Change Order

PROJECT (Name and address):	CHANGE ORDER NUMBER: 015	OWNER: 🛛
Radcliff Elementary School Renovation	DATE: February 29, 2012	ARCHITECT: ⊠
- Phase 3 1145 S. Dixie Boulevard		CONTRACTOR:
Radcliff, Kentucky 40160	·	FIELD:
TO CONTRACTOR (Name and address):	ARCHITECT'S PROJECT NUMBER: 1004	
Morel Construction Co., Inc. 627 West Main Street	CONTRACT DATE: January 10, 2011	KENTUCKY DEPARTMENT OF EDUCATION: ⊠
Louisville, Kentucky 40202	CONTRACT FOR: General Construction	EDUCATION.
Cost for materials and labor to connect the	S: I amount attributable to previously executed existing GFCI receptacle feeding the sump parting emergency circuit from the IDF Room to	oump in Lower Level Storage Room 001
The original Contract Sum was The net change by previously authorized C The Contract Sum prior to this Change Ord The Contract Sum will be increased by this The new Contract Sum including this Chan	er was Change Order in the amount of ge Order will be	5,088,000.00 175,639.96 5,263,639.96 1464.00 5,265 103.96

Work Changes Propos	sal Request	
PROJECT (Name and address): Radcliff Elementary School Renovation - Phase 3 1145 S. Dixie Boulevani.	PROPOSAL REQUEST NUMBER: 018	OWNER:
Radcliff E

E2.1A

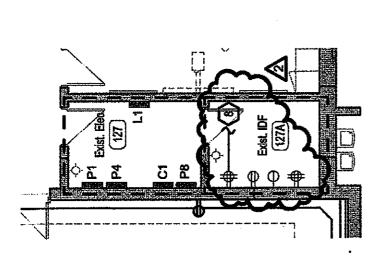
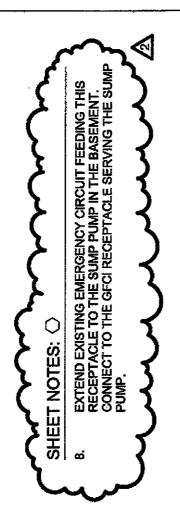
Refer to attached proposal request drawing. Provide cost for materials and labor to connect the existing GFCI receptable feeding the sump pump in the lower level Storage Room 001 to an emergency circuit. Extend the existing emergency circuit from the IDF room to the GFCI receptacle.
